Detailed Site Plan Departure from Sign Design Standards Wawa Old Branch Avenue

DSP-19056
DSDS-710

SUBJECT: Detailed Site Plan DSP-19056
 Type 2 Tree Conservation Plan TCP2-041-2020
 Departure from Sign Design Standards DSDS-710
 Wawa Old Branch Avenue

Architectural Elevations

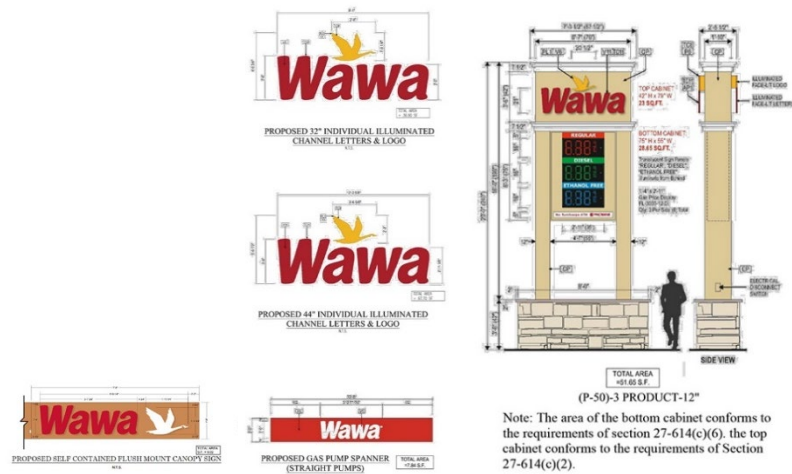
The proposed 5,600-square-foot Wawa food and beverage store is a single-story structure in the middle of the site and oriented towards MD 5. The front of the building facing MD 5 and side facing Beech Road will include multiple windows and roof features. The gas station canopy will have a slanted roof with a maximum height of approximately 21 feet with signage. The façade of the building will contain a combination of exterior insulation finishing system dryvit and manufactured stone veneer. Both the building and gas station canopy will have aluminum dutch seam roofing.

1. Prior to certification, the detailed site plan shall be revised as follows:
 - a. Label the height and dimensions for the food and beverage store and gas station canopy.
